August 31, 2021

MR CORY HART  
HCI LIMITED PARTNERSHIP  
2910 RIVER OAKS DRIVE  
MONROE LA 71201

Subject: Approval to Manage Contaminated Soil On-Site Under NR 718.12  
Amoco Oil Terminal Site, Winter Street, Superior, Wisconsin  
DNR BRRTS Activity #s 02-16-000331, 07-16-563483, 07-16-583046  
FID #816009920

FIGURE  
 2

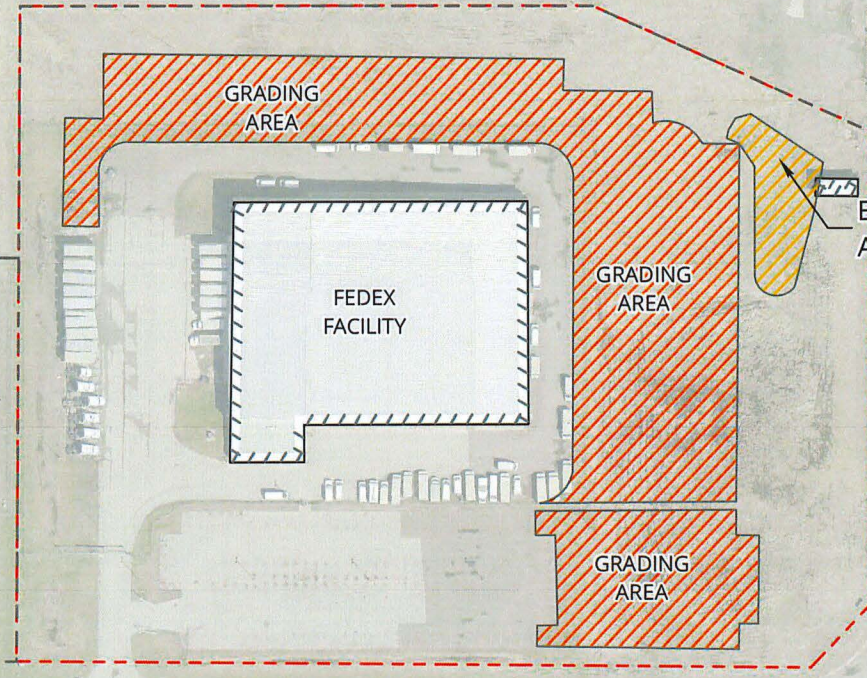
The locations where contaminated soil is proposed to be managed at Amoco Oil Terminal - FedEx Facility is depicted on the attached Figure 2, *Excess Soil Generation Locations*, dated August 24, 2021 by the BBJ Group and Figure 3, *Engineered Barriers, Dry Stormwater Pond and Soil Berm Location*.

FIGURE  
3

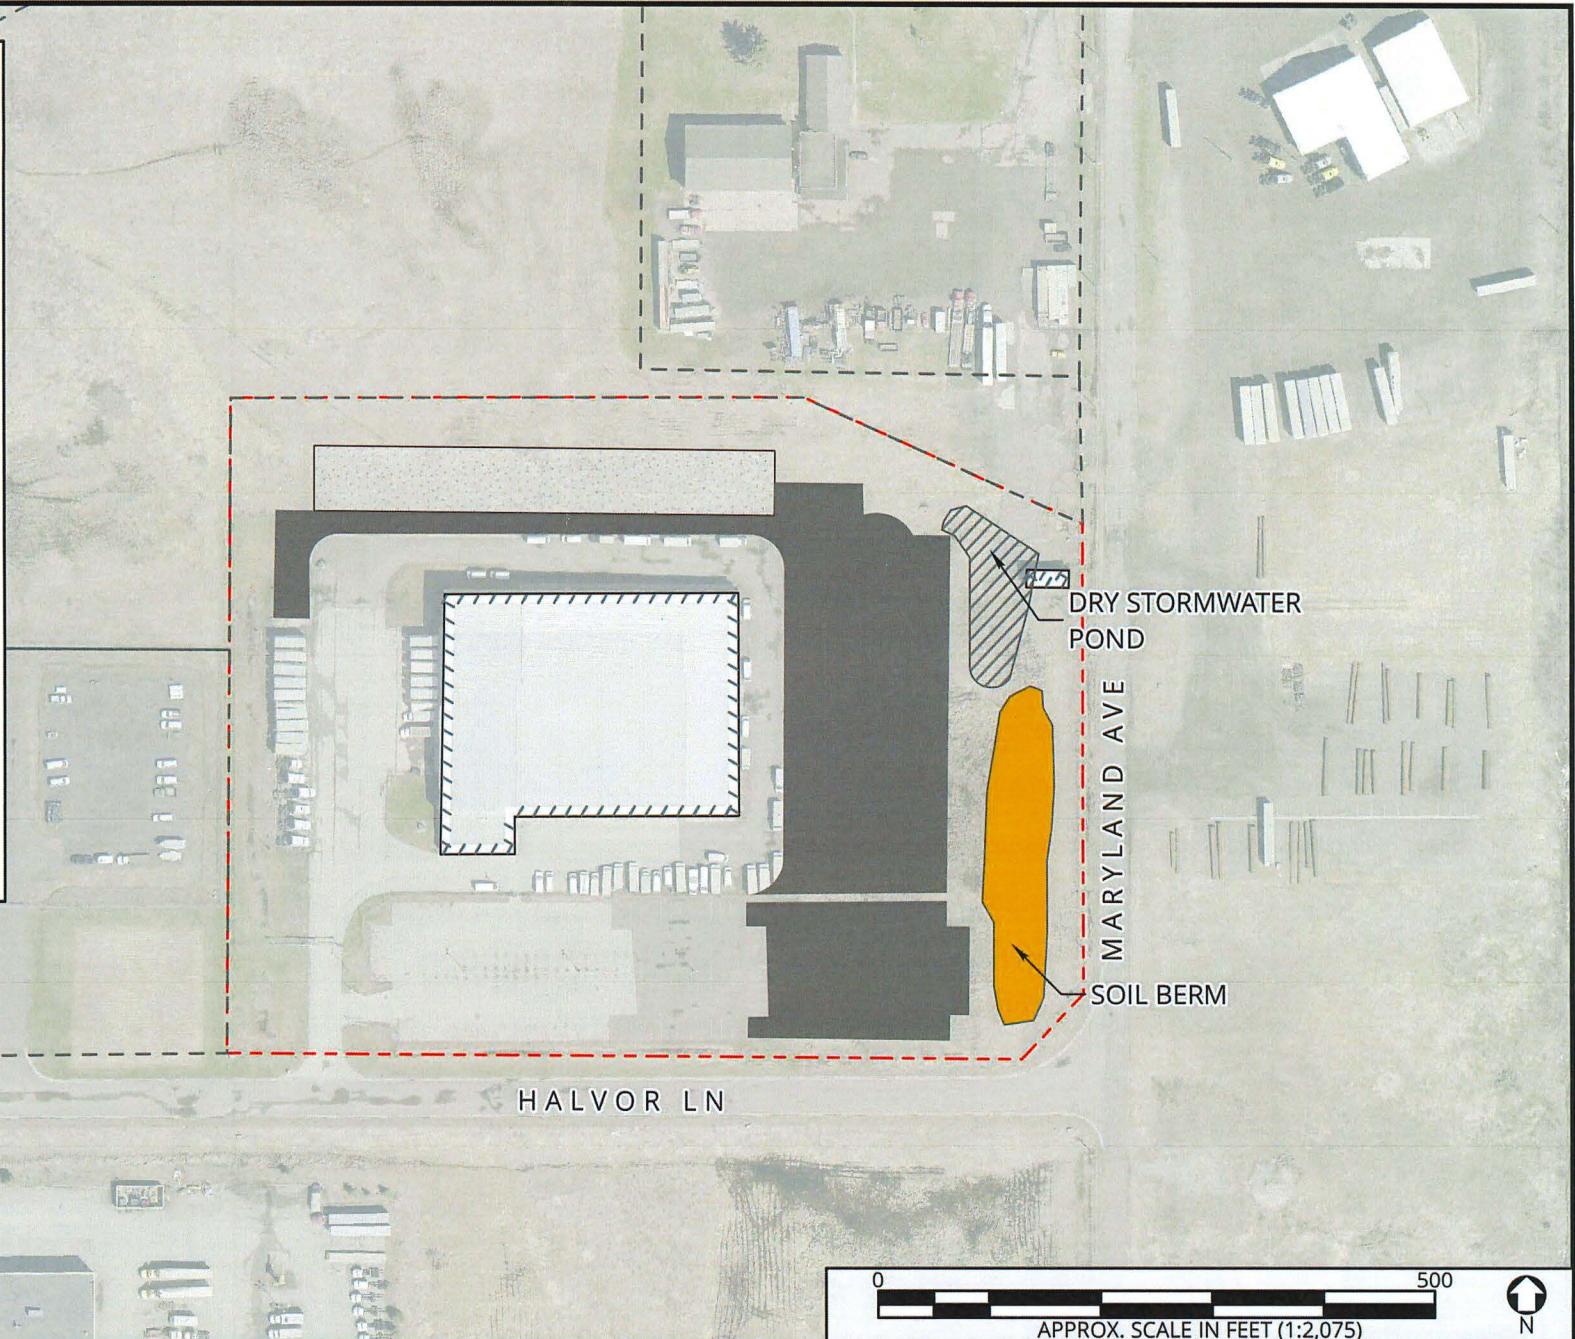
Managing contaminated soil in areas of the Amoco Oil Terminal – FedEx Facility identified on Figure 3 of the MMP, *Engineered Barriers, Dry Stormwater Pond and Soil Berm Location*, dated August 24, 2021 by the BBJ Group, will meet the locational criteria listed under Wis. Admin. Code § NR 718.12 (1) (c).

Known soil contamination will remain under the areas of soil cover as indicated on the attached Figure 3, *Engineered Barriers, Dry Stormwater Pond and Soil Berm Location*. If soil in the locations shown on the map is excavated in the future, the property owner or right of way holder at the time of excavation must sample and analyze the excavated soil. If sampling confirms that

A map is attached, Figure 3, *Engineered Barriers, Dry Stormwater Pond and Soil Berm Location*, which shows where contaminated soil is proposed to be managed and the extent of the proposed covers. Once constructed, inspections of the engineered covers will be required per Wis. Admin. Code § NR 724.13), and submittal of inspection reports may also be required per Wis. Admin. Code § 727.05 (1) (b) 3. Notification to the DNR is required before changing to a non-industrial use if the cover is approved for industrial land use, per Wis. Admin. Code § NR 727.07 (3) to ensure that the cover will be protective for that use.
